Subject: **PLANNING & DEVELOPMENT MEETING FOR WEDNESDAY 4/28/2010**

Subject: **Robertson Property - Henderson Lane North Corner of State Road 46**
Project #: 10-23000001

Dyer, Riddle, Mills & Precourt, Inc. (DRMP) is in receipt of review comments prepared by the Seminole County Government Development Review Committee as of February 27, 2010. The following summarizes our responses to your comments.

LAKE FOREST
FINAL MASTER PLAN
SEMINOLE COUNTY, FLORIDA

COVER

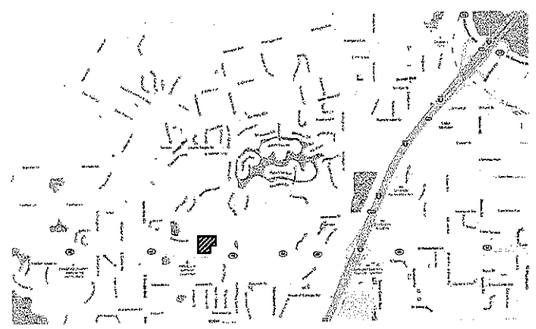
1. Comment: On sheet 1 of 9, the location map includes parcel 30-19-30-300-0110-0000, which is not included in this application, please revise.

Response: Revised, please see sheet 1.

FINAL MASTER PLAN

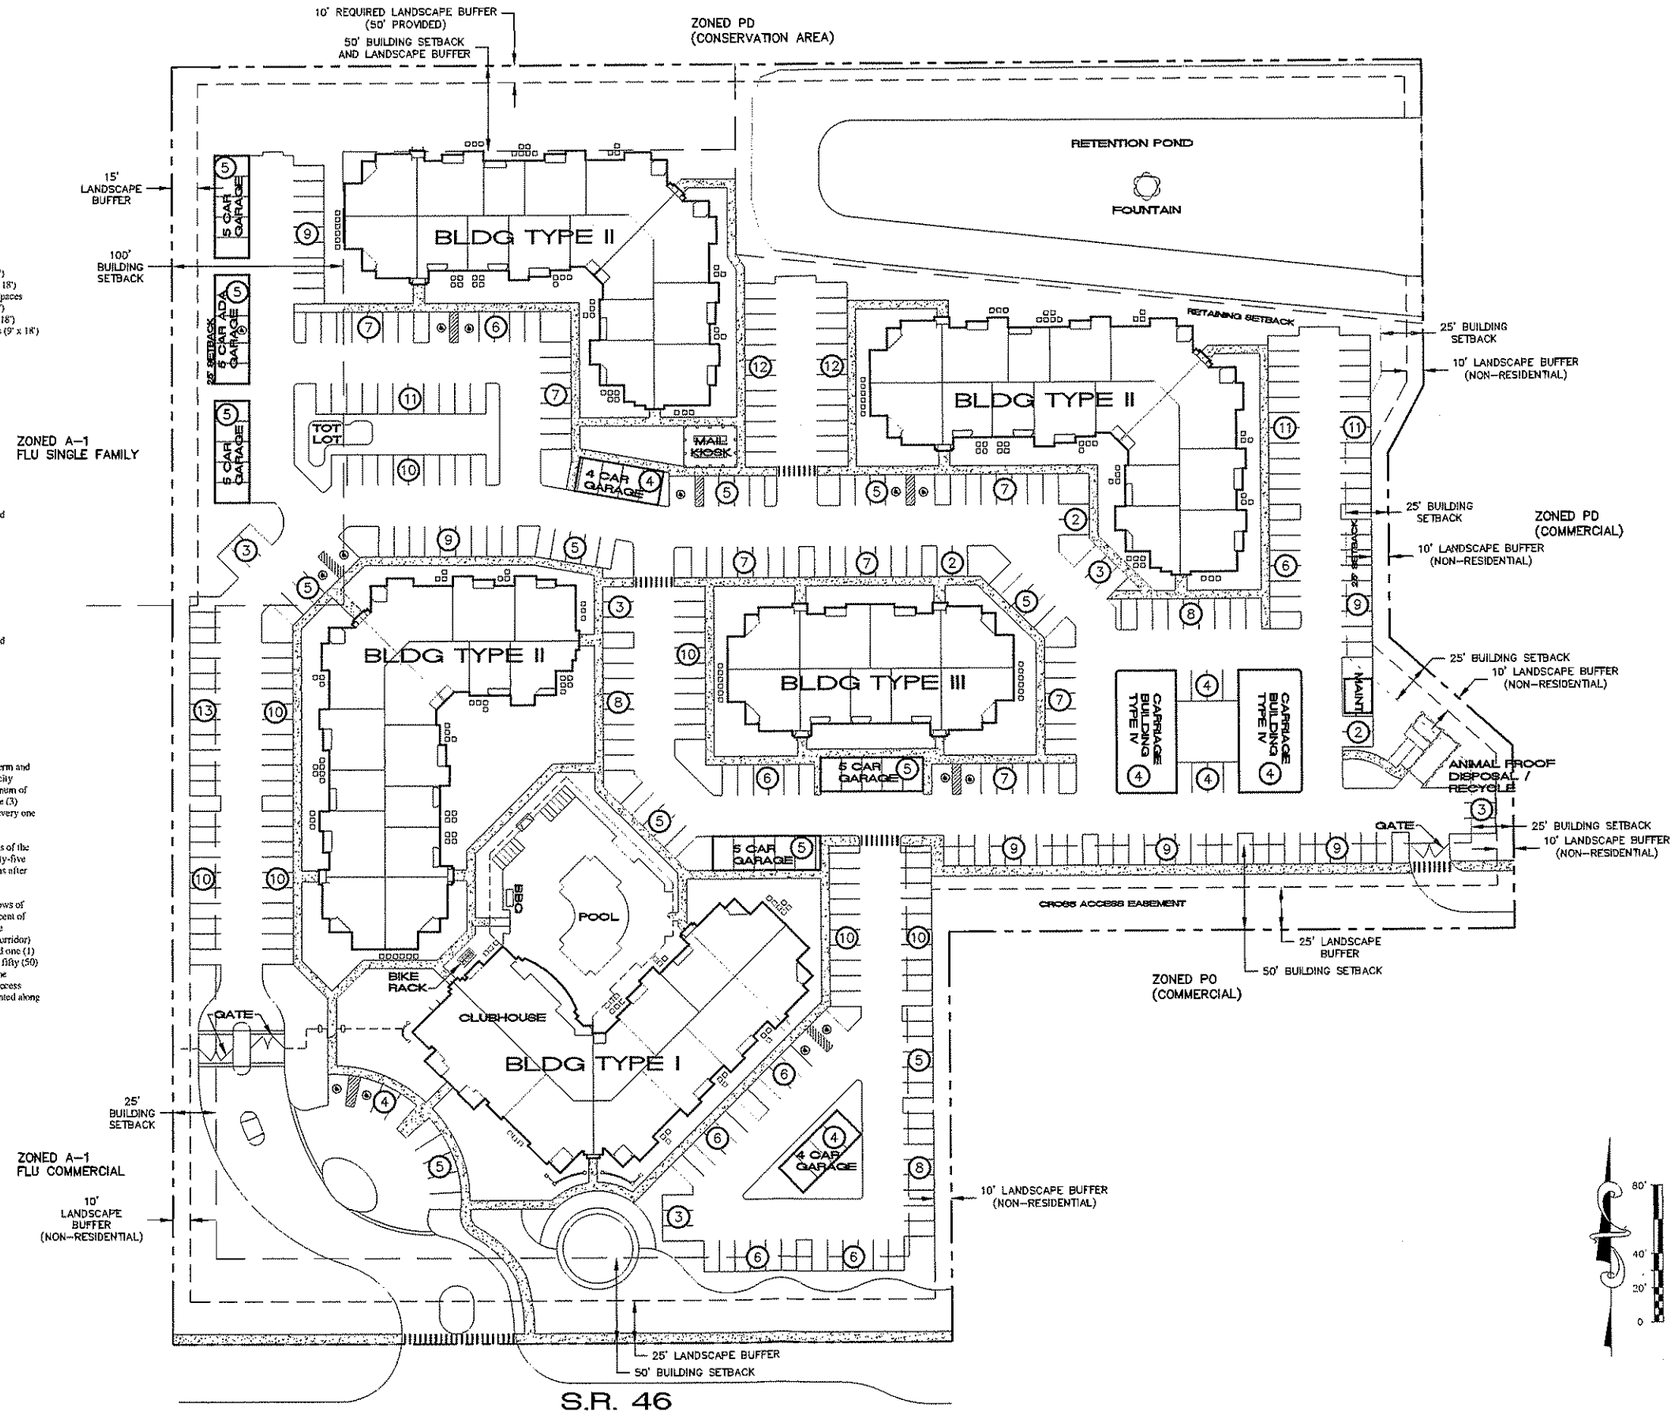
2. Comment: On sheet 7 of 9, please change the title from, "Master Plan" to "Final Master Plan".

3. Comment: On sheet 7 of 9, please provide the buffer width and content under the "Property Information" section of the sheet. Staff understands it is already called out on the plan however can it be put in data section also.

4. Comment: On sheet 7 of 9, you give the proposed open space of 4.61 acres, however where is this coming from? Can you please provide a breakdown of the 4.61 acres under "Property Information"? Also please put what the required open space percentage and acreage is for this project.

5. Comment: On sheet 7 of 9, please put the permitted uses, existing & proposed zoning, existing and proposed Future Land Use, maximum building height, and proposed setbacks, buffer widths, and buffer content under "Property Information".

6. Comment: On sheet 7 of 9, the development plan states that the required amount of parking for this development is 582, however you are only providing 356 spaces, is this correct? It is highly unlikely that staff could recommend approval of a parking variance reducing the total number of required parking spaces by 226.

8. Comment: On sheet 7 of 9, please provide bicycle racks near heavily used pedestrian areas such as the clubhouse or recreational amenities.

9. Comment: On sheet 7 of 9, please provide an internal sidewalk system connecting all areas of the proposed development.

10. Comment: On sheet 7 of 9, you are only showing two gated access points, will there also be one at the cross access with the shopping center? If so, please callout that gated access point on the plan.

12. Comment: On sheet 7 of 9, will this development be building a tot lot or any other recreational area for the community? If so please call out those amenities on the plan sheet.

13. Comment: On sheet 7 of 9, will there be automobile garages for the renters of this development? If so, please call them out on the plan.

17. Comment: On sheet 7 of 9, please provide pedestrian access to the shopping center east of this site?

20. Comment: On sheet 7 of 9, you do not distinguish what the west buffer is proposed to be on the plan, please correct. The west buffer on the sheet says "see attached specification", which is not located in your application package.

21. Comment: On sheet 7 of 9, please provide a sidewalk connection from the proposed sidewalk on SR 46 to the club house or other pedestrian entrance to the development.

24. Comment: On sheet 7 of 9, please change the units for capacity information from mgd to gpd.

25. Comment: On sheet 7 of 9, where will the mailbox kiosk be located, please call it out on the plan?

26. Comment: On sheet 7 of 9, it appears the handicapped parking spaces are not located near the entrances to the apartment buildings, is there a reason for this?

28. Comment: On sheet 7 of 9, is there a reason the dumpster is situated near the Forest Glen subdivision, Can this dumpster be relocated to a different section of the development?

29. Comment: On sheet 7 of 9, please put the net buildable area and net residential density under "Property Information".

Response: Revised, please see sheet 7.

Response: Revised, please see sheet 7.

Response: Revised, please see sheet 7.

Response: Revised, please see sheet 7.

Response: Please see revised development and parking calculation.

Response: Bike rack provided by clubhouse, please see sheet 7.

Response: Sidewalk provided, please see sheet 7.

Response: **Gates called out, please see sheet 7.**

Response: **Tot lot and & BBQ area provided, please see sheet 7.**

Response: **Garages called out, please see sheet 7.**

Response: **Sidewalk provided, please see sheet 7.**

Response: **See buffer content under property information.**

Response: **Sidewalk connection provided, please see sheet 7.**

Response: **Revised, please see sheet 7.**

Response: **Noted on plans, please see sheet 7.**

Response: **Revised, please see sheet 7.**

Response: **Dumpster relocated, please see sheet 7.**

Response: **Provided, please see sheet 7.**
